Division 6 - Lincoln Laboratory
Massachusetts Institute of Technology
Lexington 73, Massachusetts

SUBJECT: PROPOSED CHANGES IN FSQ-7 MEMORY

Date: July 13, 1954

Abstract: A significant reduction of the cathode count coupled with an increase in operating speed of the FSQ-7 Memory banks can be achieved by a redesign of some of the sections of Memory. In order of increasing difficulty these are: the Digit Plane Drivers, the Sense Amplifiers, and the address selection system. Approximately 6 man-months of engineering time would be required to effect these changes.

Figure I

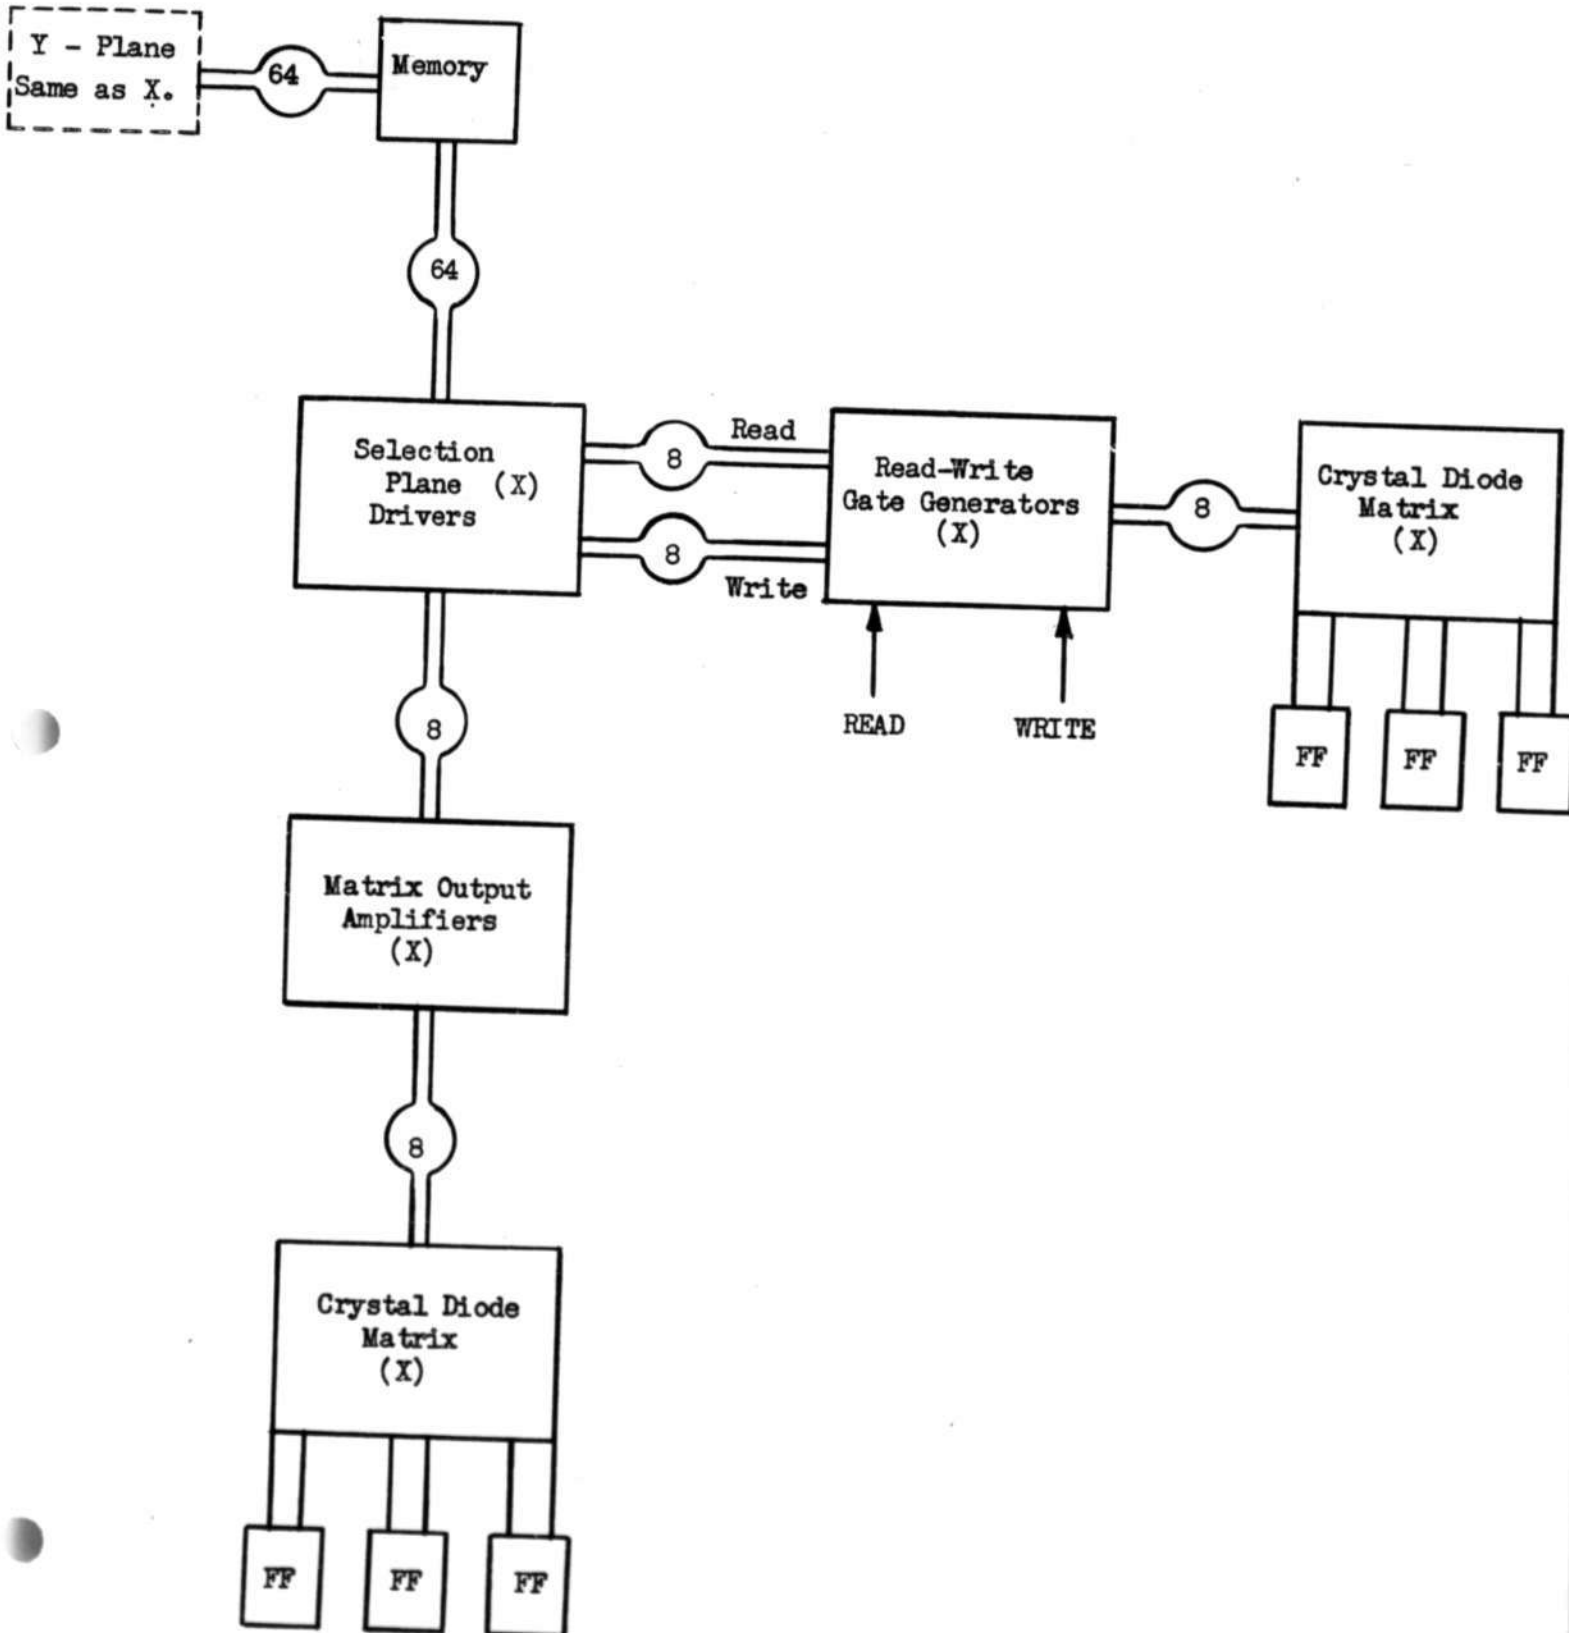
One of the major difficulties in the present selection system is the result of the extremely large amount of capacity which the Read-Write Gate Generator is required to drive. This capacity has the effect of reducing the source impedance presented to the pulse output transformer by a given selection-plane driver tube. A secondary detrimental effect of this capacity is the increased circuit delay which it causes. (Almost a full microsecond is required to establish current in the memory.) In an attempt to alleviate this condition, a recent study of selection systems was initiated. The number of Gate Generators was increased in order to reduce the capacity which a given Gate Generator is required to drive. At the same time the number of Matrix Output Amplifiers was reduced. Figure I is a block diagram of this system.

Happily, this contemplated system requires far fewer cathodes than the old system (192 compared to 304). The new circuits which would be used as Matrix Output Amplifiers and Read-Write Gate Generators will not be as critical with respect to input levels as were the older circuits, and since the 32-position crystal-diode matrix would no longer be used for address translation, (2 8-position crystal-diode switches are used instead) the Memory Address Register cathode followers, which presently consist of 9 cathodes per F.F. output (216 total), could be redesigned to use at most 3 cathodes per F.F. output (72 total).

Three units in this system require some further development time (the Matrix Output Amplifier, Memory Address Register Cathode Followers, and Read-Write Gate Generators). In addition, the Selection Plane Driver panels would be redesigned, since all that will appear on these panels would be 5998's and pulse transformers, eliminating the need for plug-in Selection Plane Driver Panels. The engineering time required is estimated at approximately 1 man-month per unit in addition to the time required to alter the mechanical design of the existing memory stall and Selection Plane Driver Panels.
